COTTAGE GROVE PLANNING COMMISSION

January 27, 2025

Planning Staff Report

Planning Case Nos. ZA2025-004 & PP2025-004

Sheet 20 of 60

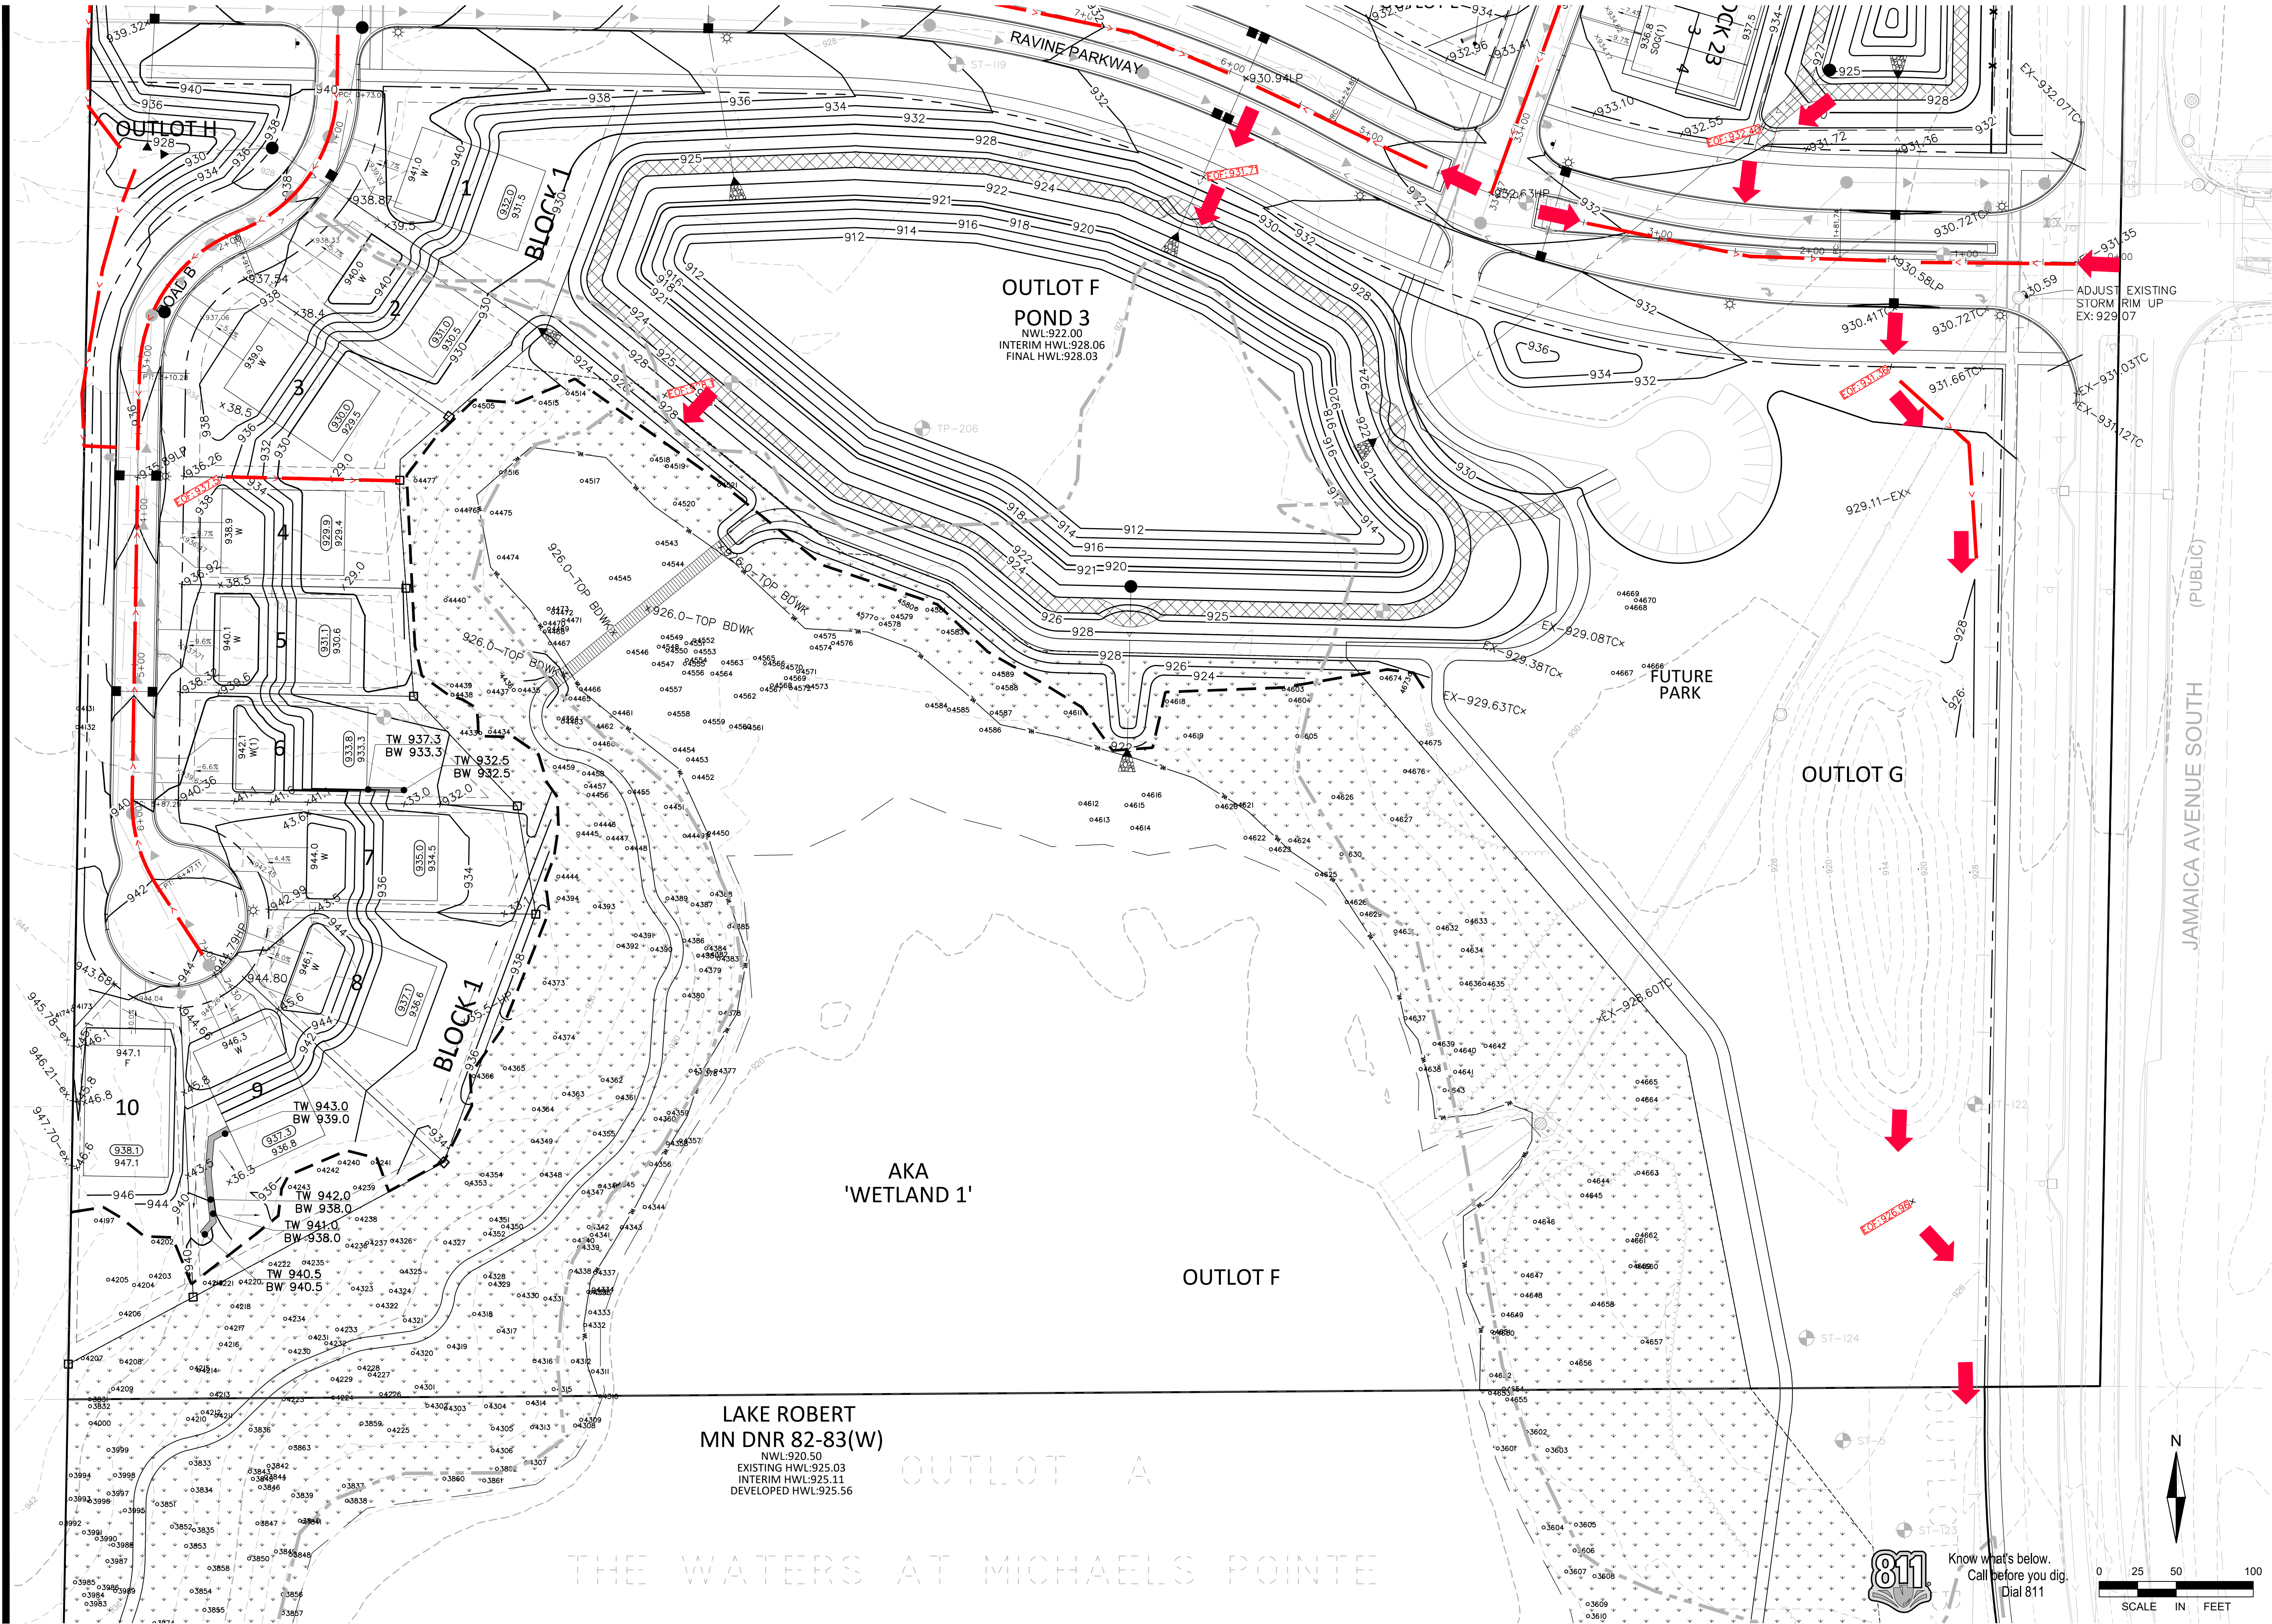
- a. Lot 2 Block 1: The current Zone A floodplain extends onto the house pad (See Sheet 21). Without submitted documentation that the floodplain has changed, this house would officially be within the floodplain.

Sheet 33 of 60

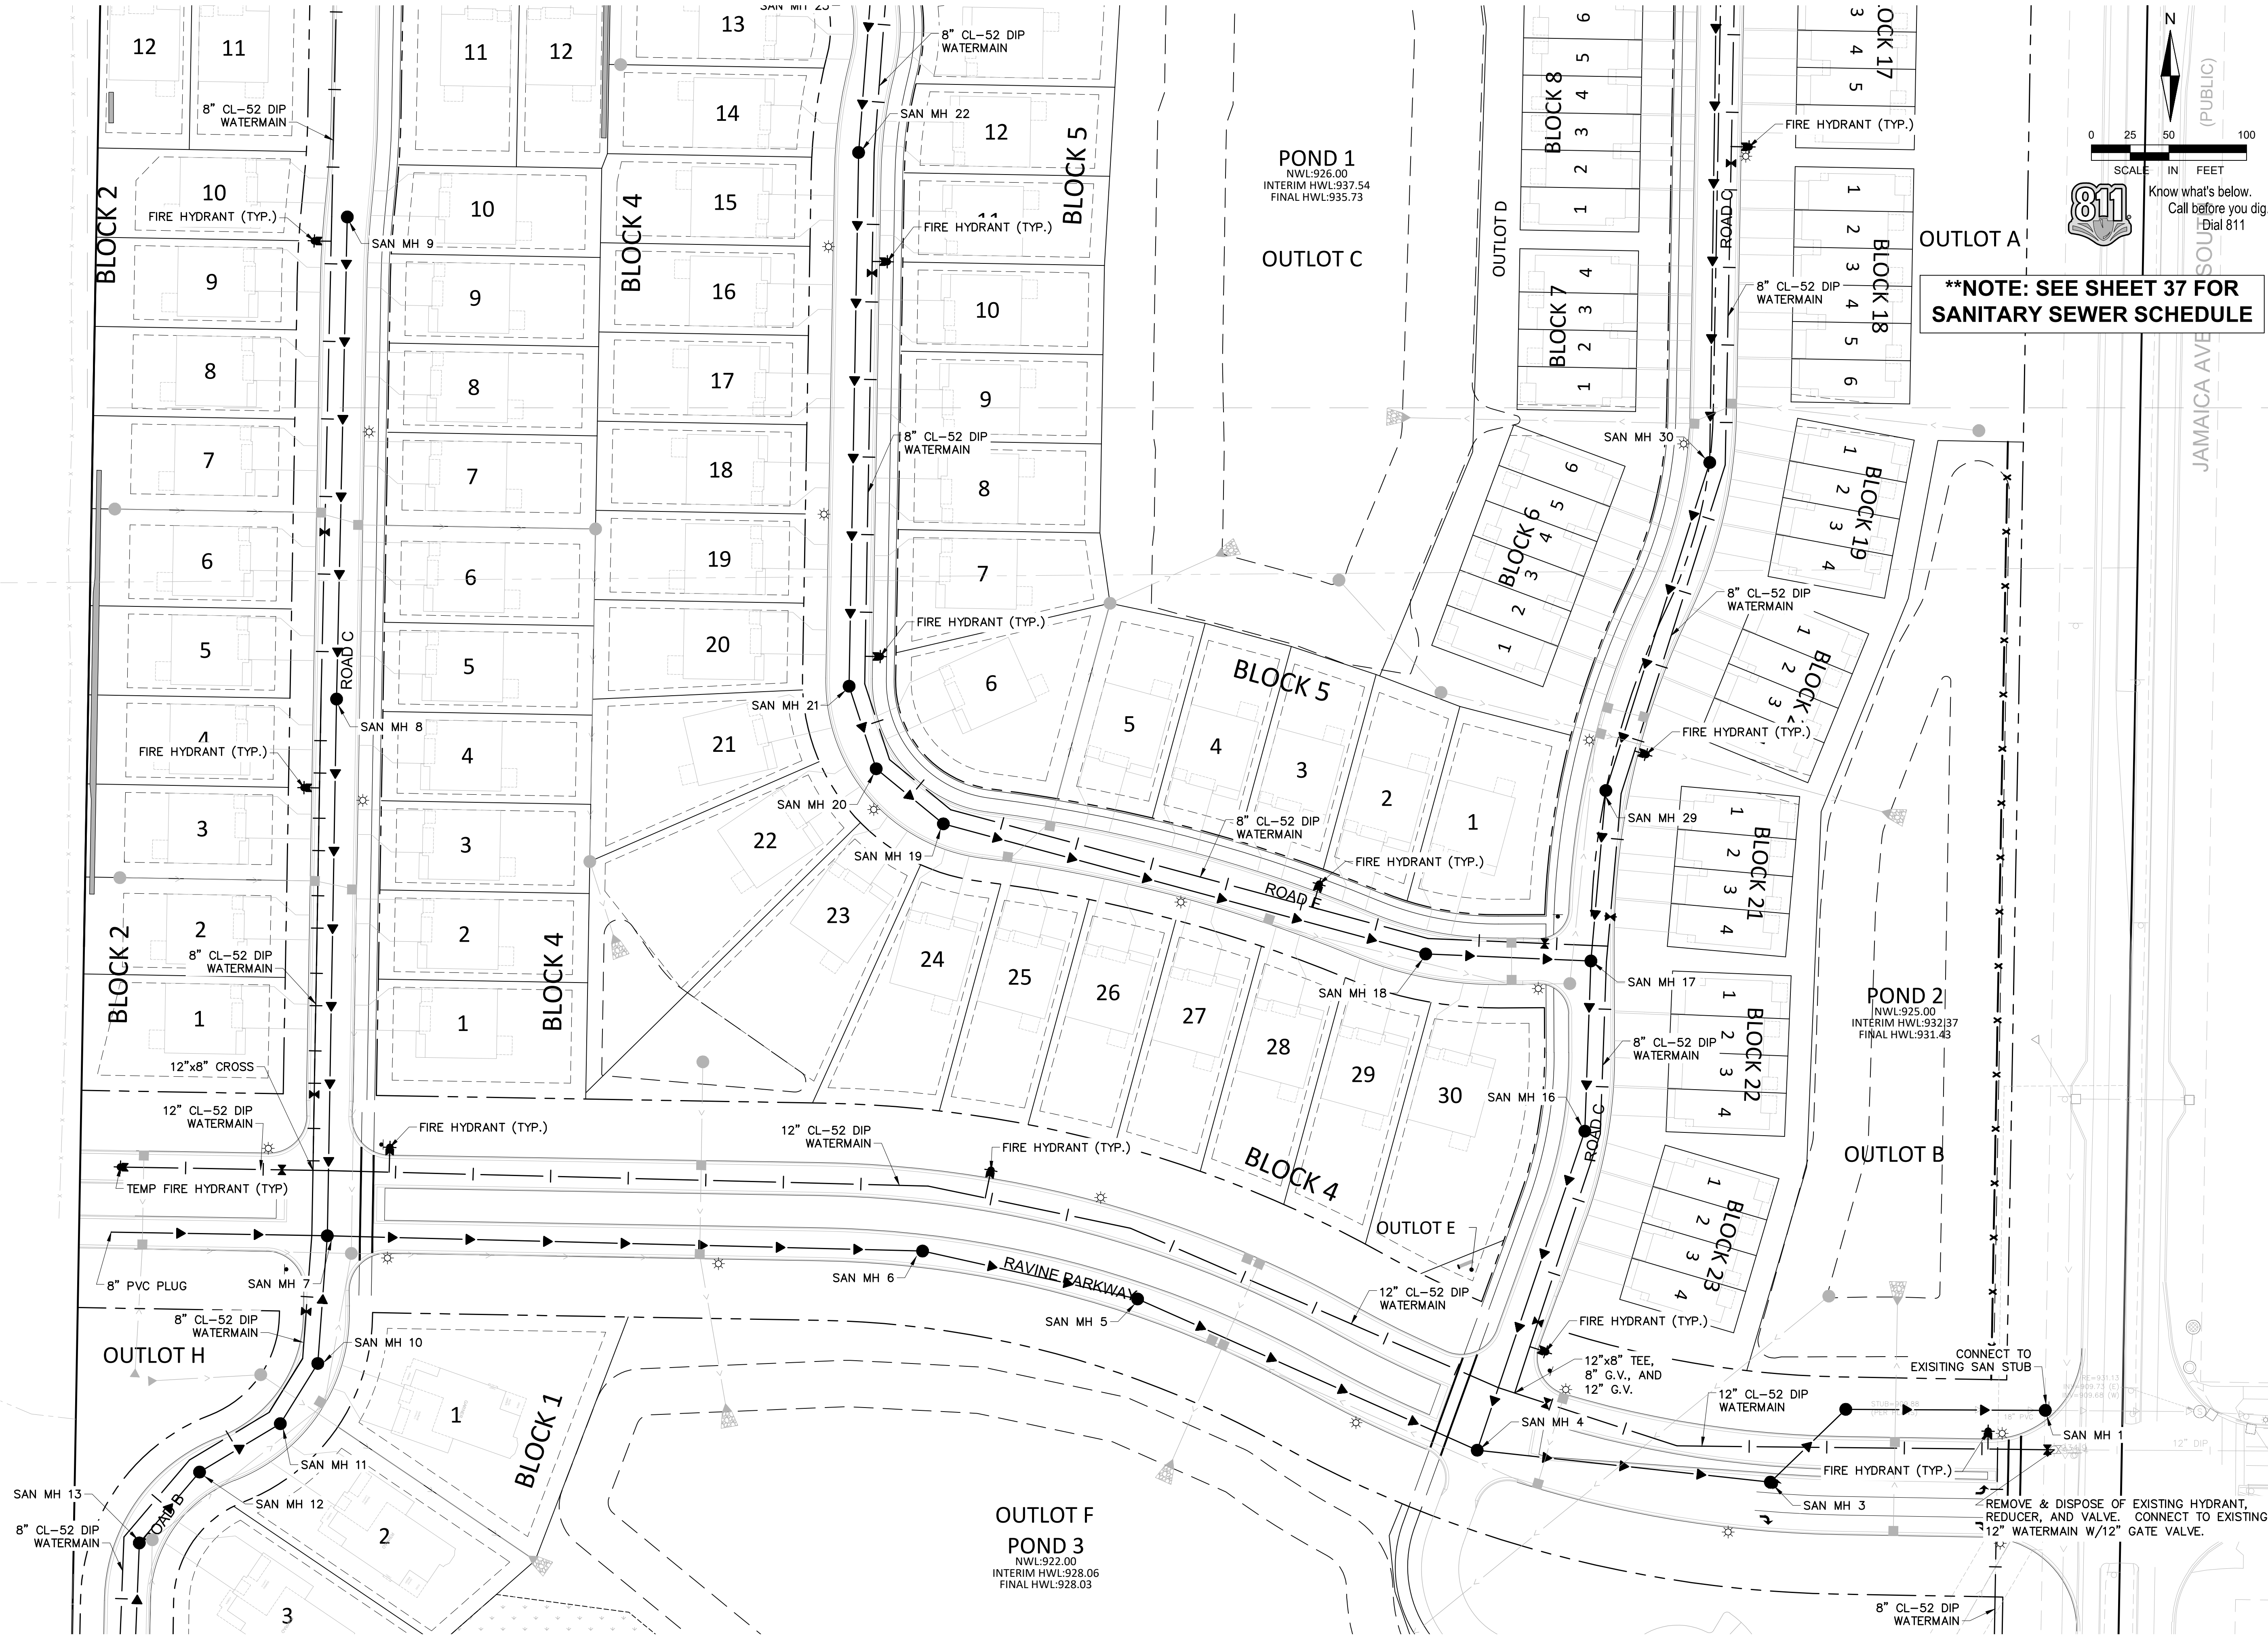
- a. Ensure valve placement achieves an isolation of 20-25 homes maximum.
 - i. The multi-family area should be adjusted accordingly.
- b. Coordinate with comments on Sheet 34 related to Ravine Parkway.

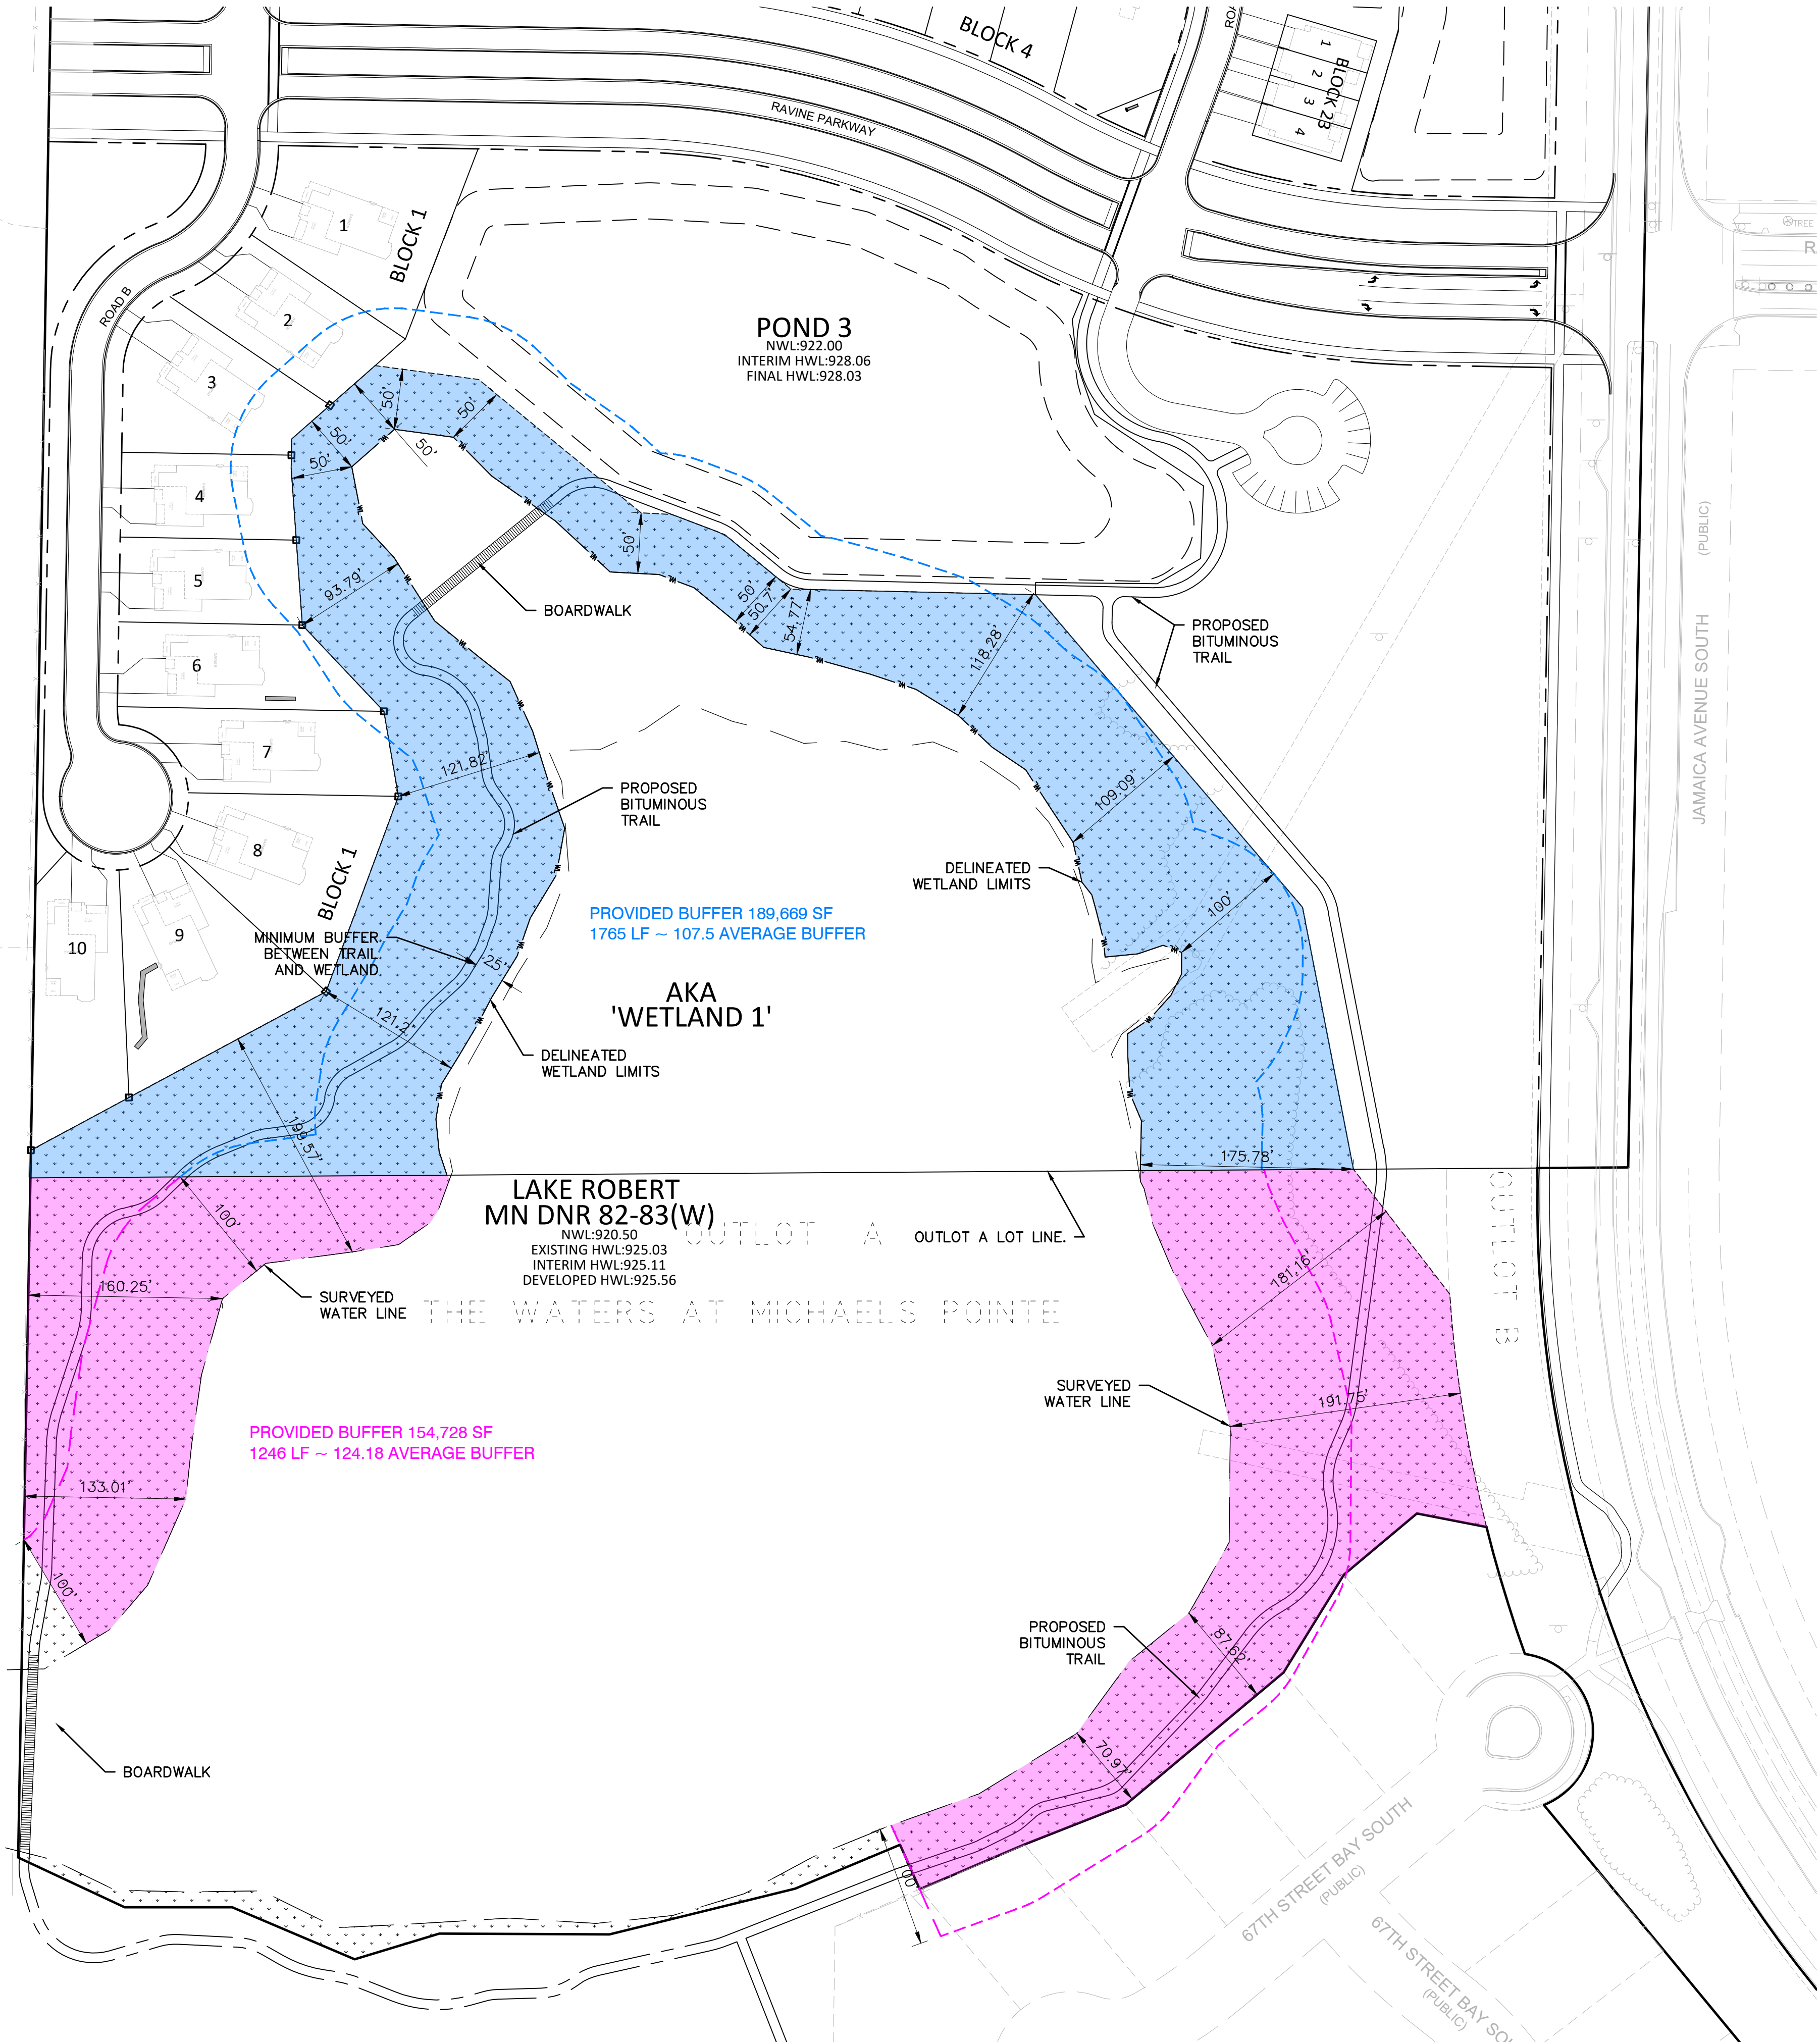
- b. The HydroCAD model simulates the NW Low Point as a 60" horizontal orifice connected to a 36" storm drain. Sheet 42 indicates an R-4342 casting is proposed. This casting has only 2 sq. ft. of opening and is much smaller than the 60" diameter orifice simulated in HydroCAD (19.6 sq. ft.). Please update Sheet 42 to a larger grate casting and simulate the open area provided by the casting. Please also simulate in HydroCAD the 36" storm drain along the full length from CB528 to Pond 1.
